Permit Application Review

Permit No. 2020-123
Received complete: February 5, 2021

Applicant: Michael Margulies; Valerian, LLC.
Consultant: Robbie Latta; Civil Site Group
Project: 3-story Multi- family Building
Location: 4425 Valley View Road: Edina
Rule(s): 3,4,5,10,11, and 12
Reviewer: BCO

C2.0

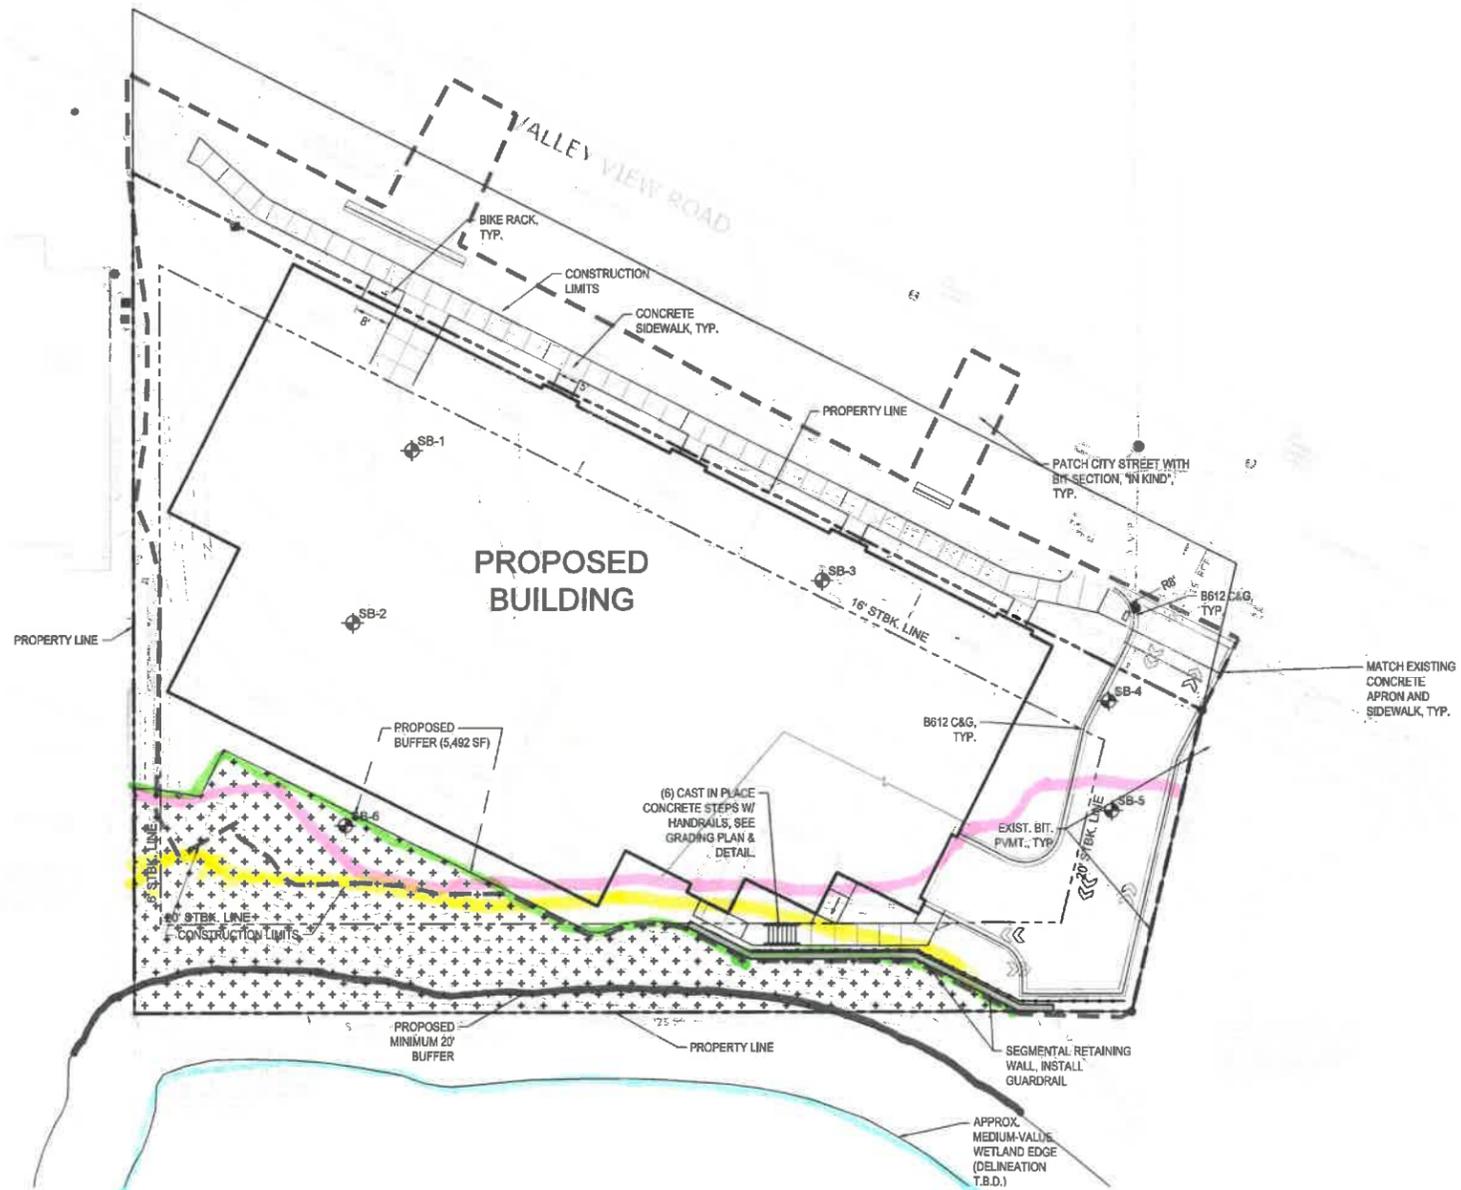
- The buffer area provided if taken to the top of the slope is 7,600 square feet (Rule 3.4.2). This is the area below the pink/red line shown on the attached figure.

- A buffer area of 4,612 square feet, the area below the yellow line, would be required for compliance with Rule 3.4.1b. A buffer area of 5,492 square feet is shown to be provided – the area below the green line on the attached figure. This area, 5,492 sq. ft., is a 28% shortfall (2,108 sq. ft.) in buffer area compared to the required buffer area (7,600 sq. ft.).

- The existing slope upgradient from the wetland is heavily overgrown with a few trees but primarily buckthorn. The buckthorn is proposed to be removed and the area revegetated with a MnDot wet prairie seed mixture and deciduous trees. This buffer restoration proposed complies with the criterion of Rule 3.4.6.

- Stormwater runoff from the site currently sheet flows from the existing site impervious areas down the slope (described above) to the wetland. Most runoff, from the redeveloped site, will be conveyed instead by storm sewer to the property limits. Less than 336 sq. ft. of the post-development site impervious area will be directed to the buffer.

The effectiveness and purpose of the buffer is not diminished if the buffer complies with Rule 3.4.1b (40-foot) rather than extending to the top of the slope as required by Rule 3.4.2.
